RE: Scheduling of Planning & Zoning Board (PZB) Hearing: Tara Village Preliminary Plat

**RE: Tara Village – Preliminary Plat Application
Review of Revised Application**

RE: Review of Revised Application, Dated August 8, 2017: Tara Village Preliminary Plat

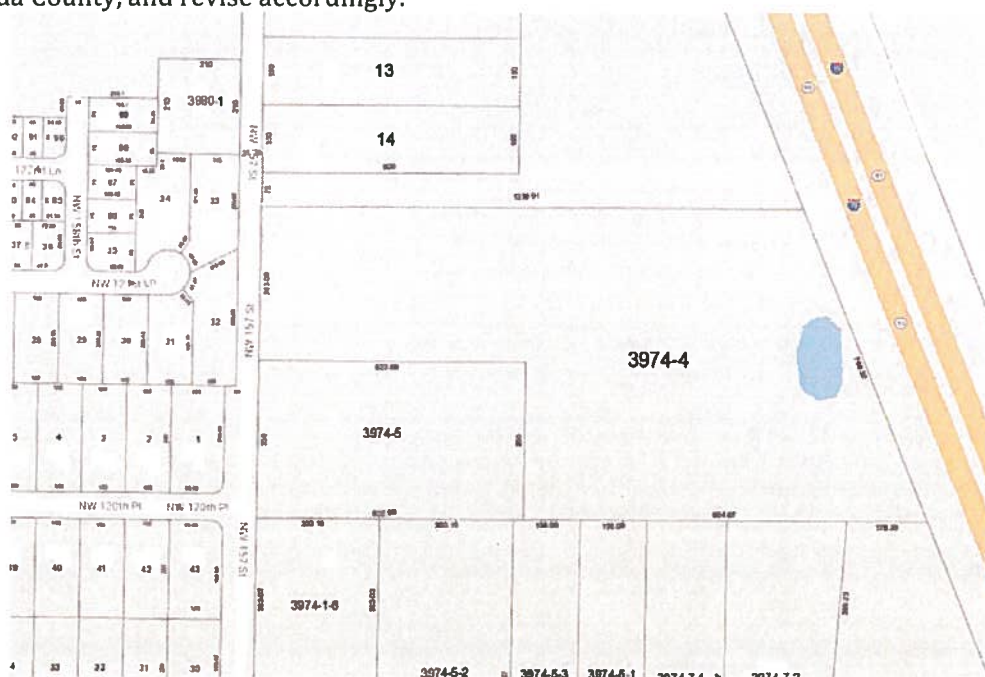
Remaining Issue: Section 3, #7, of the PD ordinance states, "[t]he natural buffer shall remain undisturbed in all areas and in its natural state, except where necessary to provide ingress/egress, stormwater management facilities, and/or utility service to the Project.

Stormwater management facilities shall not be placed within the 25 foot natural buffer area along the eastern property line or along the southern property boundary line of the project..."

The note added to the preliminary plat states, "a 25' wide natural buffer is provided along all property boundary lines of the project in accordance with the PD Ordinance". The PD ordinance allows for ingress/egress and utility service within the 25' natural buffer area, and such areas are depicted within 25' natural buffer area on the plat. The note must be revised to clarify that the natural buffer shall remain undisturbed in all areas and in its natural state, except where necessary to provide ingress/egress and utility service to the Project.

RESPONSE: *The preliminary plat notes have been adjusted to clearly define the 25’ natural buffer areas, with or without ingress/egress and utility service, the 25’ Drainage Vegetated Natural Buffer*
